REMARKS/ARGUMENTS

Appl. No. 10/727,752
Amndt. dated August 16, 2004
Reply to Office action of June 7, 2004

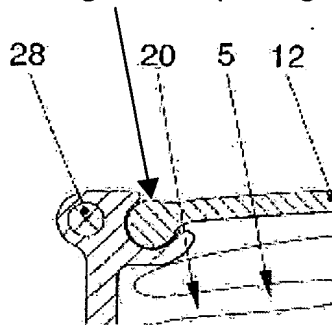
More specifically, the Examiner stated that the drawings must show the feature of a cover that is releasably latched to the edge of the outlet opening as defined in claim 20 or the feature must be deleted from the claims.

Figs. 2 and 3, the edge of the cover 10 that is latched in the groove along the airbag outlet opening looks, when viewed in cross-section, like a ball and socket type connection, which is illustrated below.

The feature of a cover 10 that is releasably latched to the edge of the airbag outlet opening 9 is shown in Figs. 2 and 3. Figs. 2 and 3 show that the edges of the cover 10 are latched in grooves along the edge of the airbag outlet opening 9. In

cover 10 is releasably latched in the groove along the edge region of the airbag outlet opening 9

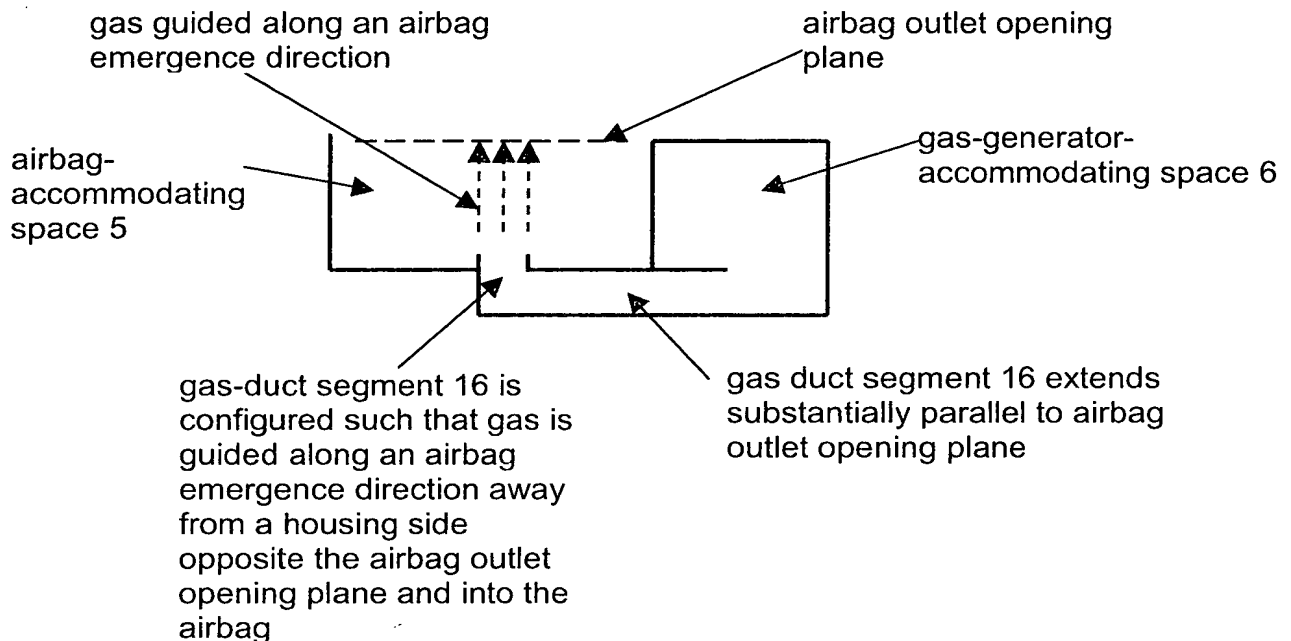
More specifically, the Examiner stated that the specification fails to describe the structure of a cover that is releasably latched to the edge of the outlet opening. The Examiner asked what kind of releasable latch is used, how the cover opens, and whether the cover is hinged.

Figs. 2 and 3 show how the cover 10 is releasably latched to the edge of the airbag outlet opening 9. Figs. 2 and 3 show that the edges of the cover 10 are held in a groove along the

edge of the airbag outlet opening 9 such that a hinge connection is provided.

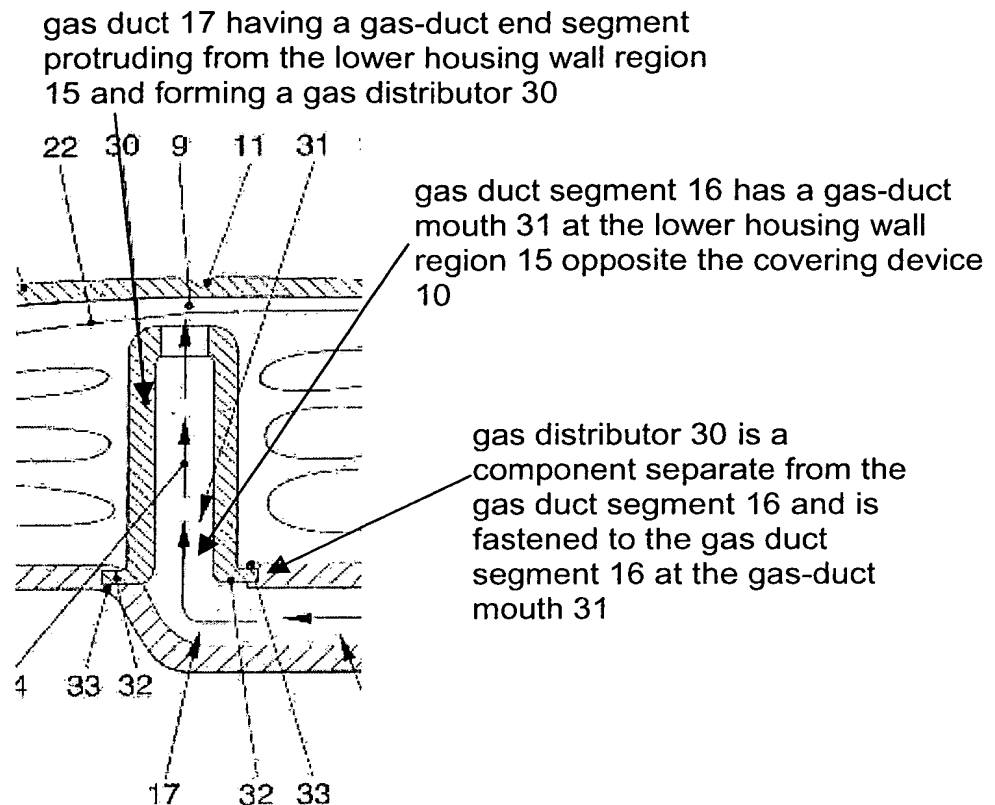
The Examiner stated that lines 34-47 of claim 1 contradict lines 39-41 of claim 1. Applicant is of the opinion that the objected to language is not contradictory and no changes are necessary. Figs. 2 and 3 show that the gas duct segment 16 extents substantially parallel to the airbag outlet opening plane and that the gas duct segment 16 is configured such that gas is guided along an airbag emergence direction. The simplified drawing below illustrates that lines 34-37 and lines 39-41 of claim 1 are not contradictory.

The Examiner objected to "said gas-duct segment" in claim 7, line 4 as being indefinite because more than one such segment has been introduced. No correction is believed to be necessary because the claim language is consistent. The gas duct segment 16 in claim 7, line 4 refers to the gas duct segment 16 in claim 1. The "gas duct end segment" of the gas duct 17 that forms the gas distributor 18; 30 is different from the "gas duct segment" 16.
